Access Compliance Report

Public Rights-of-Way

(Curb Ramps)

Intersection ID: 21239	Main Street: CAMBRIDGE BELTWAY DR	Cross Street: S TRYON ST	Location: NW
ADA ID: F285CAA93284	Ramp Type: PerpDiag	Initial Pass/Fail: Fail	Overall Compliance: No
Severity Score: 36.25			
Codes/Mitigation Info/Possible Solution		Field Measurements/Component Compliance

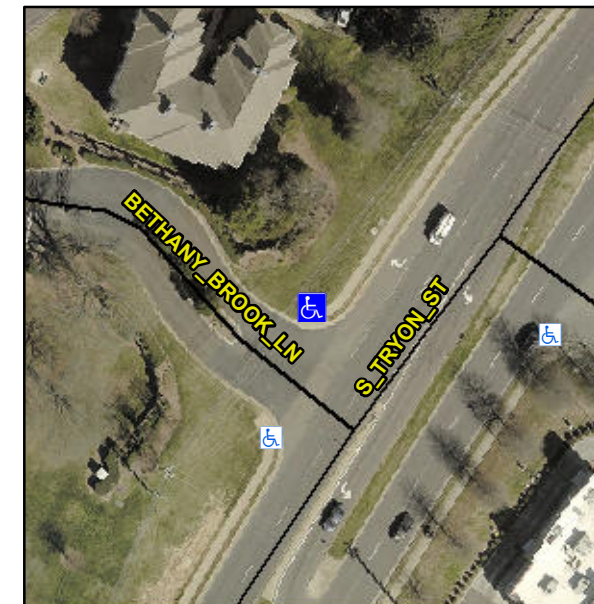
Remove & Replace Curb Ramp With Two New Directional Ramps or Equivalent.

Not Found, R304.5.1, R304.5.3

Compliance	Description	Data	Compliance	Description	Data
N/A	Ramp Length (in)	93.0	Yes	Ramp Slope (%)	5.5
No	Ramp Width (in)	31.0	No	Ramp XSlope (%)	3.3
N/A	Flare Type LT	N/A	N/A	Flare Type RT	N/A
N/A	Flare Slope LT (%)	N/A	N/A	Flare Slope RT (%)	N/A
N/A	Flare Traversable LT?	N/A	N/A	Flare Traversable RT?	N/A
N/A	Landing Length (in)	N/A	N/A	DWS Provided?	N/A
N/A	Landing Width (in)	N/A	N/A	DWS Contrast?	N/A
N/A	Landing Slope (%)	N/A	N/A	DWS Length (in)	N/A
N/A	Landing X Slope (%)	N/A	N/A	DWS Full Width?	N/A
N/A	Landing Curb? (Y/N)	N/A	N/A	DWS Offset (in)	N/A
N/A	Shared Landing?	N/A			
N/A	Gutter Ponding?	N/A	N/A	Gutter Slope (%)	N/A
N/A	Gutter Lip Ht (in)	N/A	N/A	Gutter X Slope (%)	N/A
N/A	Painted X Walk1?	No	N/A	Painted X Walk2?	No
	X Walk 1 Direction	To SW		X Walk 2 Direction	To SE
N/A	X Walk 1 Width (in)	N/A	N/A	X Walk 2 Width (in)	N/A
	X Walk 1 Slope (%)	3.5		X Walk 2 Slope (%)	1.5
	X Walk 1 X Slope (%)	0.5		X Walk 2 X Slope (%)	2.3

N/A	Ramp inside XWalk1?	N/A	N/A	Ramp inside XWalk2?	N/A
	Road Slope (%)	2.4	N/A	Clear Space?	N/A
	Road X Slope (%)	0.7	N/A	Clear Space to XWalk (in)	N/A
N/A	Any Obstructions?	N/A	N/A	Storm Grate/Utility Hazard?	N/A
	Obstruction Type			Storm Grate/Utility Type	
		N/A			N/A
			Yes	Surface Condition? (G/P)	Good
